Agenda Item 3

1055 Beverly Place

Staff Report

1055 Beverly Place

PROPOSED SITE PLAN - ENLARGED

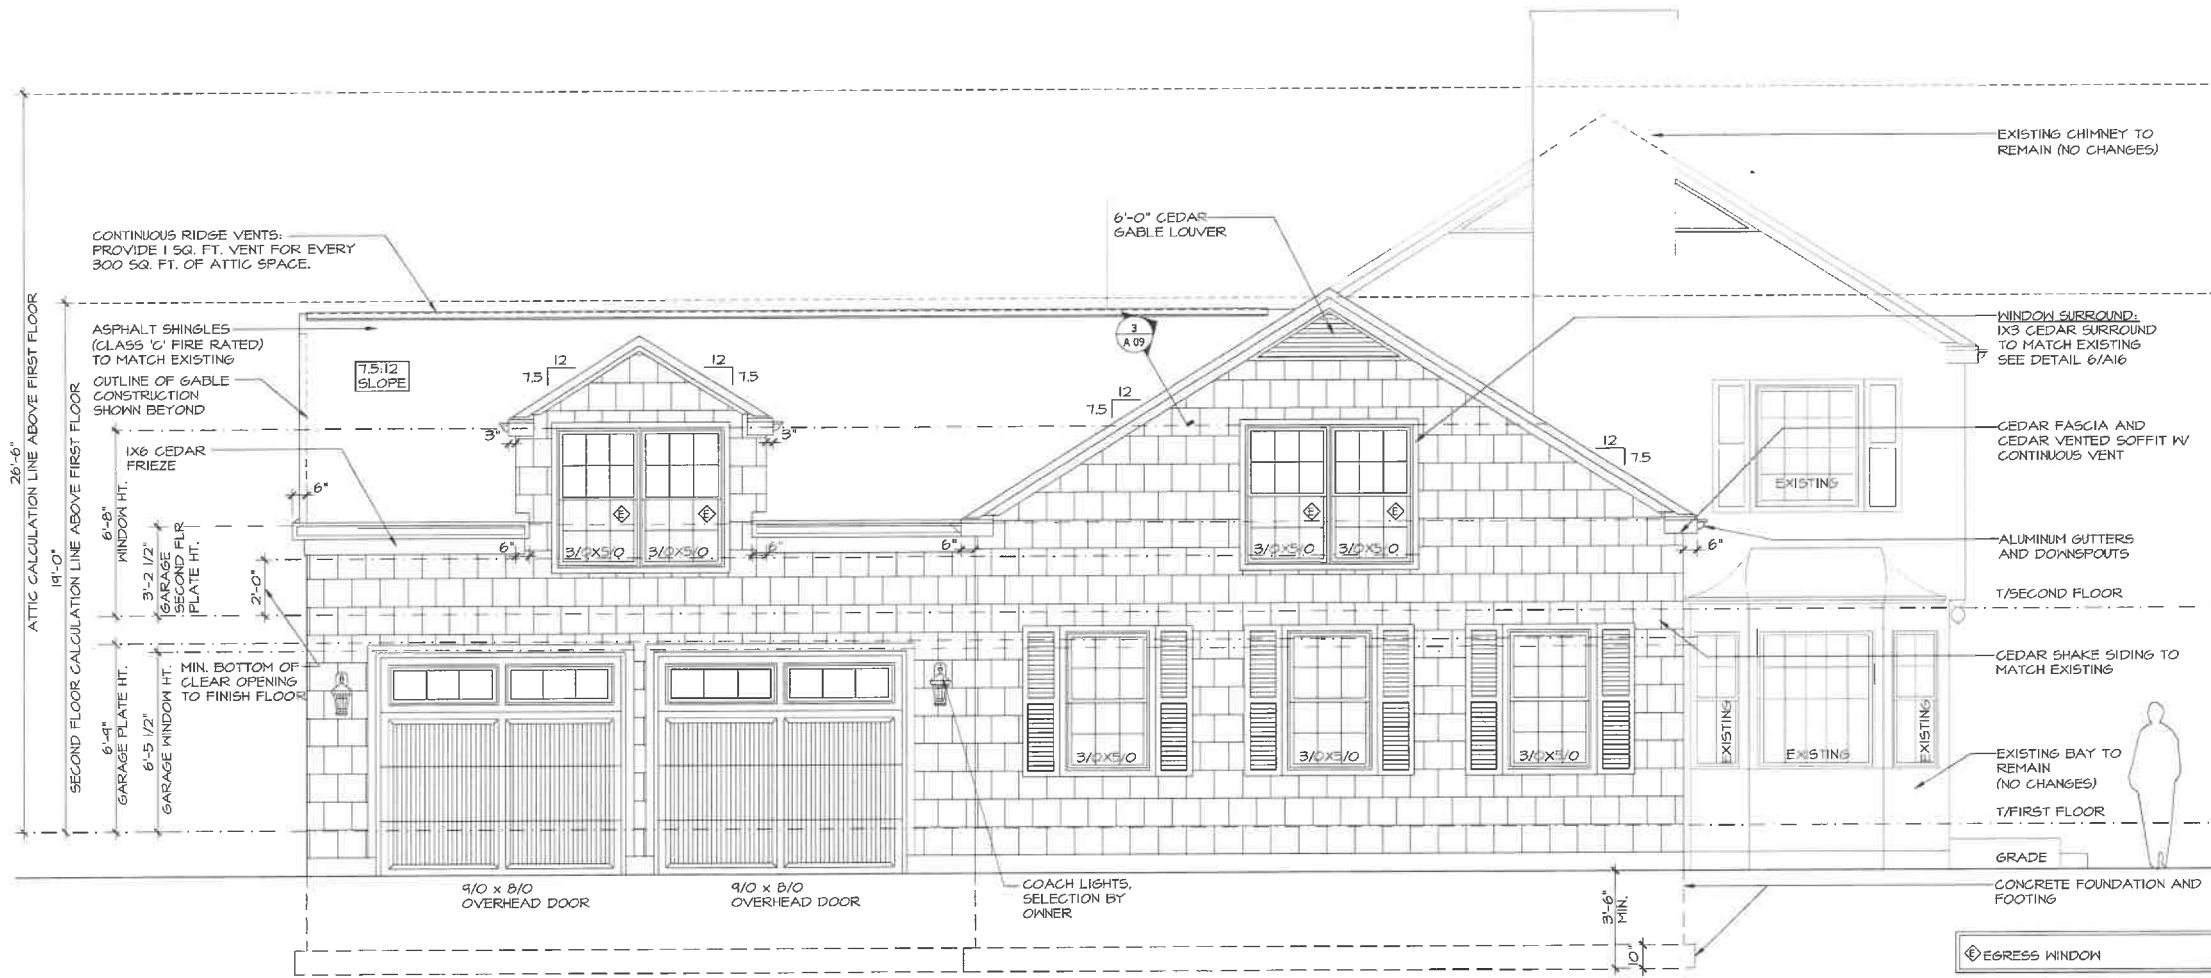
The driveway will remain in the current location and will be expanded slightly on the west side to accommodate the reoriented garage doors. As noted above, a zoning variance is required because the driveway will exceed 16 feet. Although minimizing the extent of variances is advisable, in this case, some limited further widening of the driveway to the west should be considered before the plan is presented to the Zoning Board of Appeals to assure that the driveway is as functional as possible given the limitations of the site. Straight driveways, without space to turn around, are common in the area however, adequate space to maneuver into and out of a garage is important.

A concrete walkway from the new driveway to the front of the home is proposed to accommodate visitors who may park in the driveway rather than on the street. The existing walkway from the front entrance to Beverly Place and the rear patio remain.

1
AR 17
PROPOSED LEFT ELEVATION

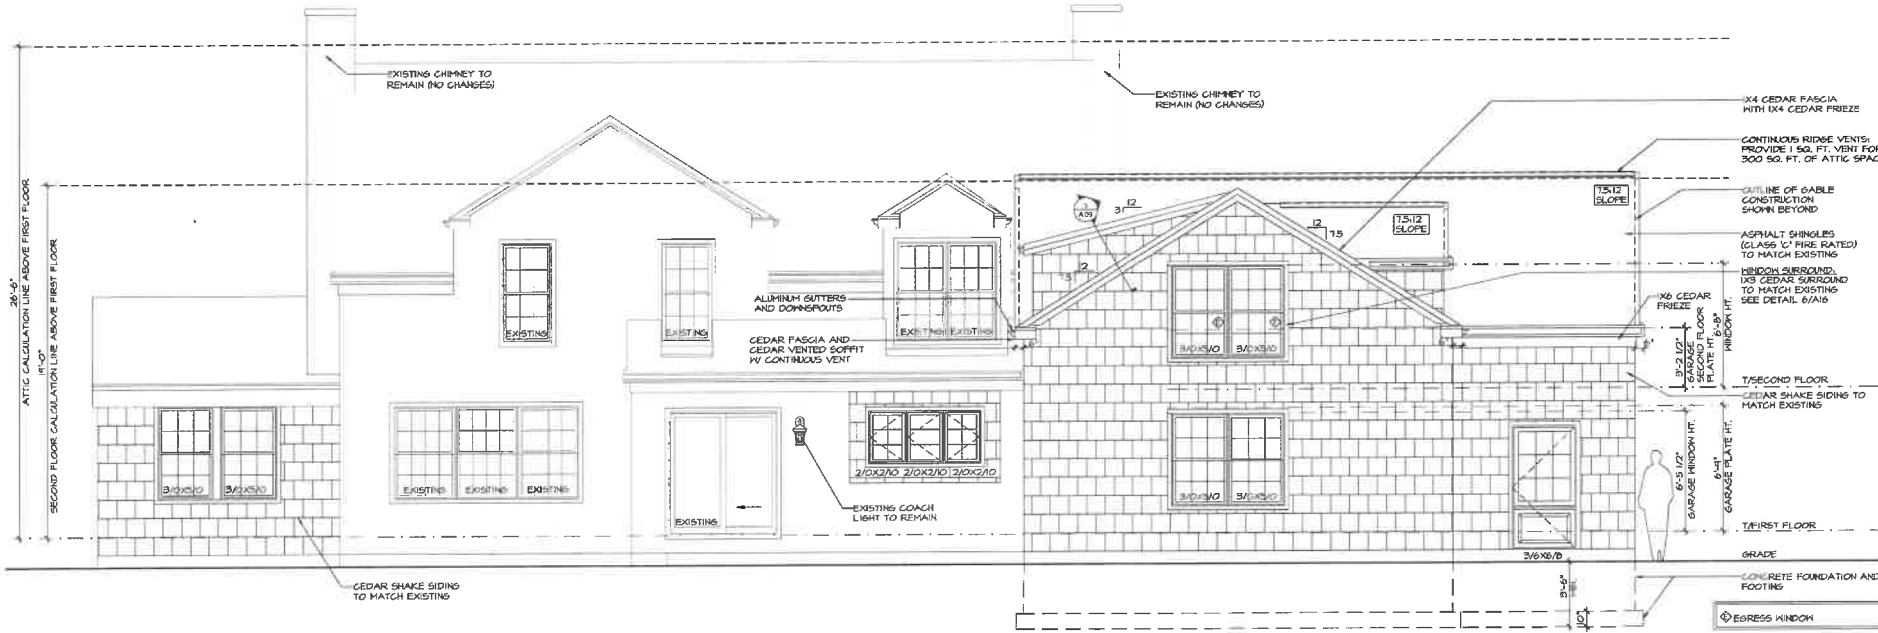
As noted above, currently, the garage door is on the east elevation and is minimally visible from the street. The proposed garage faces Longwood Drive but unlike in the September plan, the garage doors are setback an additional ten feet from the north property line and also setback from the main mass of the addition. In the September plan, the garage doors were more prominent on the Longwood Drive streetscape and from southbound Beverly Place due both to location and tree loss. A dormer with a gable roof sits above the two garage doors and rises to a point below the ridge of the roof.

Decorative overhead garage doors are reflected on the north elevation. Lites appear across the top of the garage doors and the lower portion of the doors appear to be detailed with vertical texture. Given the prominence of the garage doors on the streetscape, the character and quality of the doors will be important. Information should be provided by the petitioner to clarify the material, style, and detailing of the garage doors.

- Provide clarification on the siding material and on the details and materials of the garage doors.

1
AR 14
PROPOSED FRONT ELEVATION

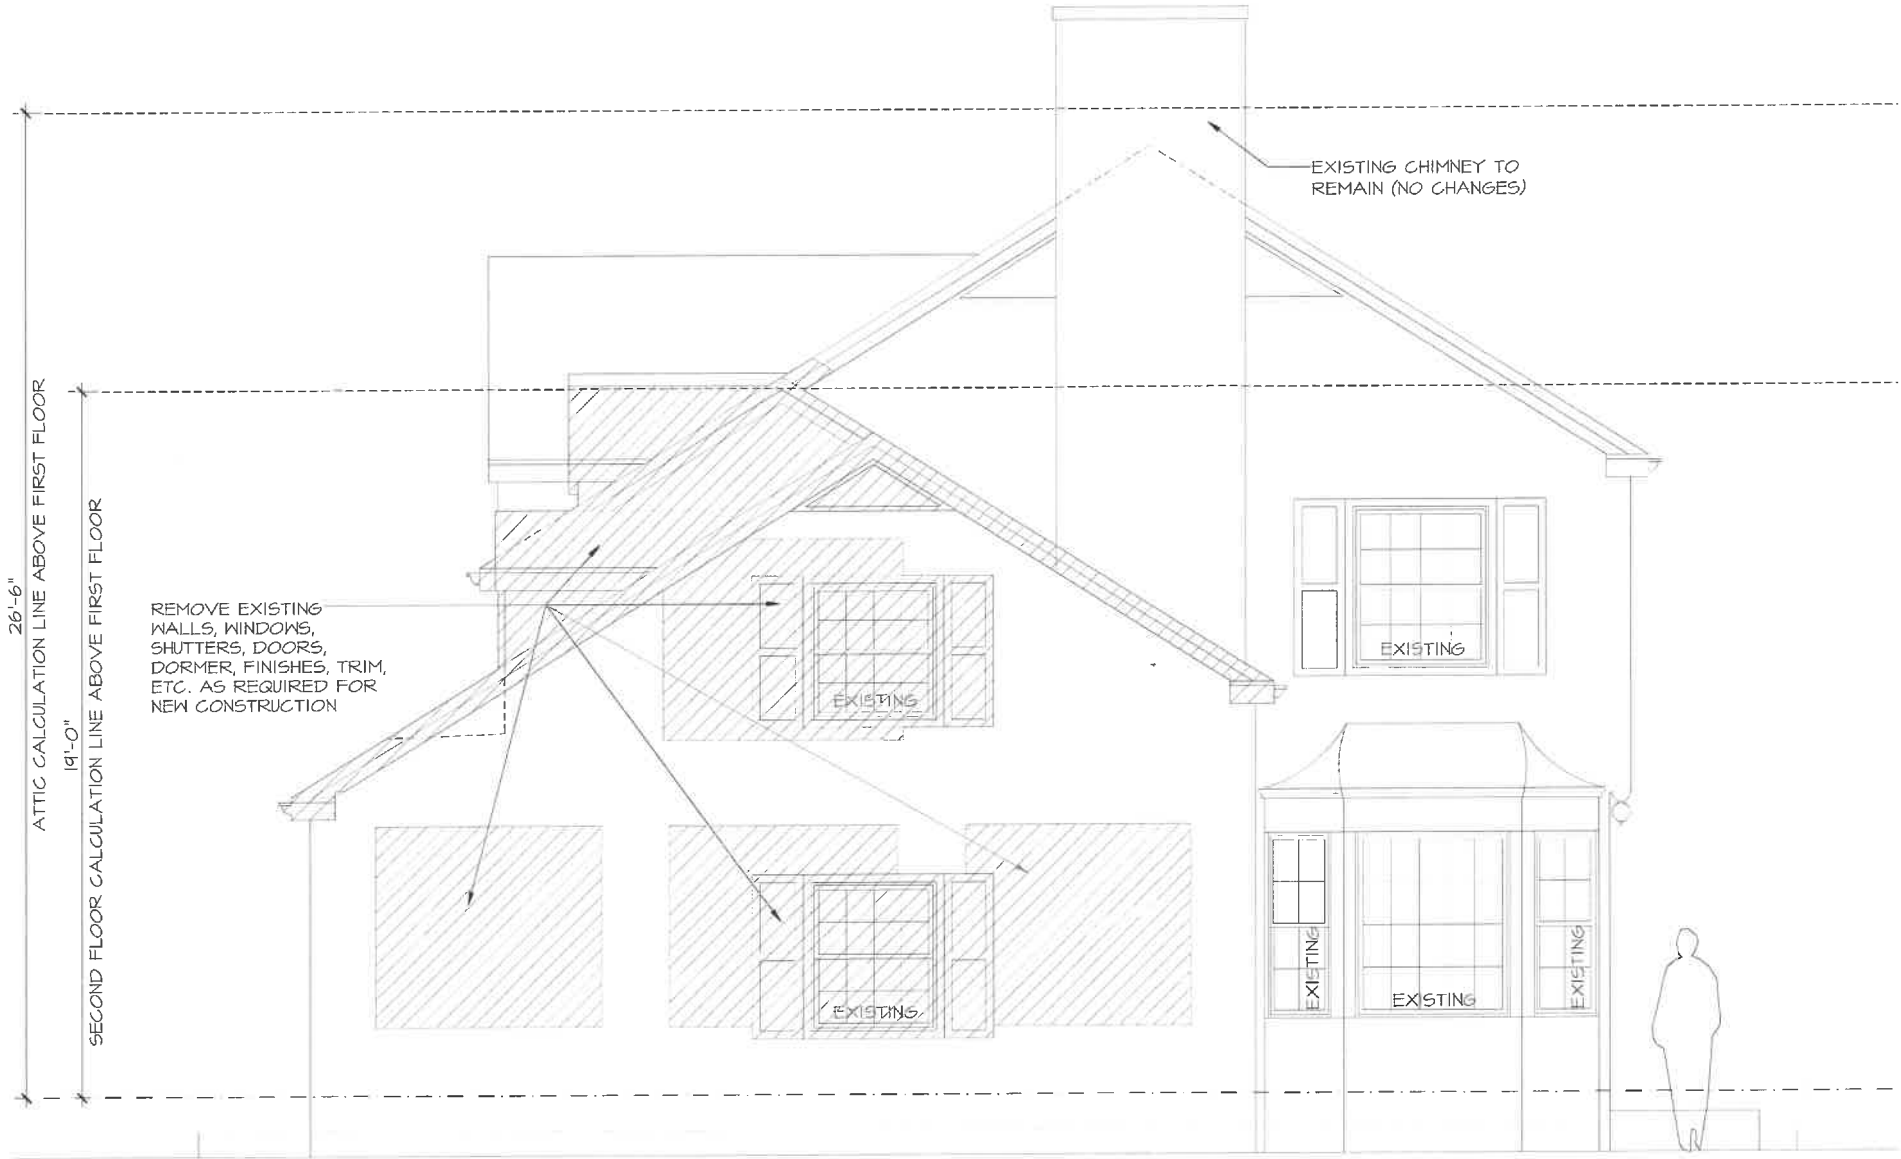
On the west elevation, the front of the house which faces Beverly Place, the addition steps down from the main mass of the house and although larger, it balances to some extent the smaller screen porch element at the south end of the house. The east elevation of the addition is clean and simple. It is detailed with three double hung windows. The previously proposed plan reflected solid panels above each window, the panels were eliminated. The windows are detailed with properly proportioned shutters.

PROPOSED EAST ELEVATION

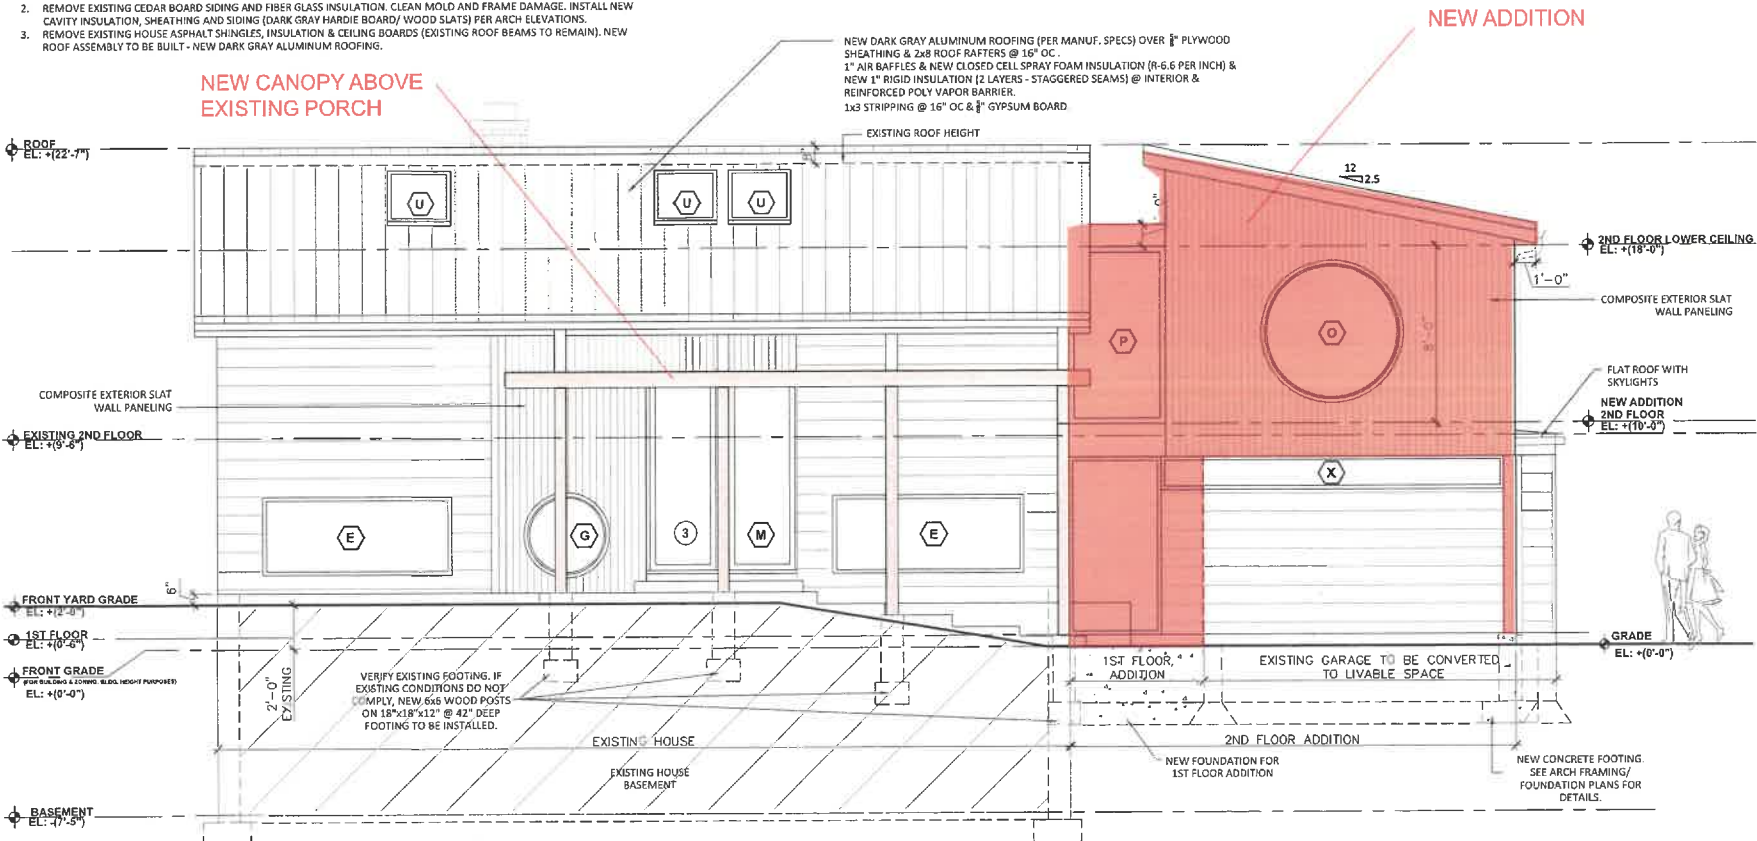
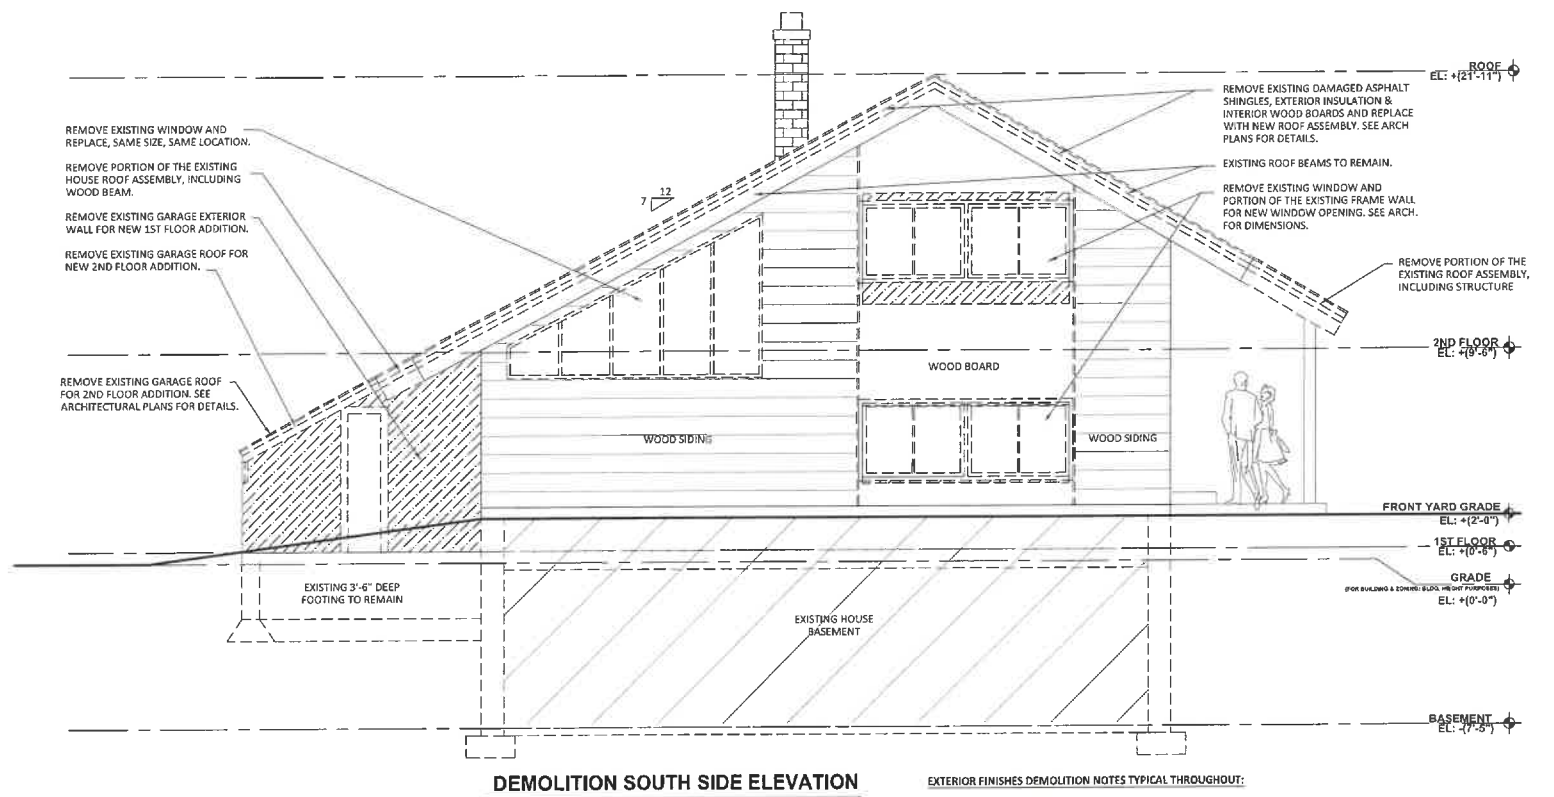
Board input is requested on the large, front facing, second floor, round window.

1. Alternative designs for the front facing round window and the carport shall be submitted and will be subject to staff review in consultation with the Chairman. If appropriate, these elements shall be returned to the Board for final approval.
2. All modifications to the plans including those made in response to Board direction or discussion, or as the result of final design development, shall be clearly called out on the plan submitted for permit and a copy of the plan originally provided to the Board shall be attached for comparison purposes. Staff is directed to review any changes, in consultation with the Chairman as appropriate, to verify that any changes are consistent with the Board's approval prior to the issuance of any permits or if further Board review is required.
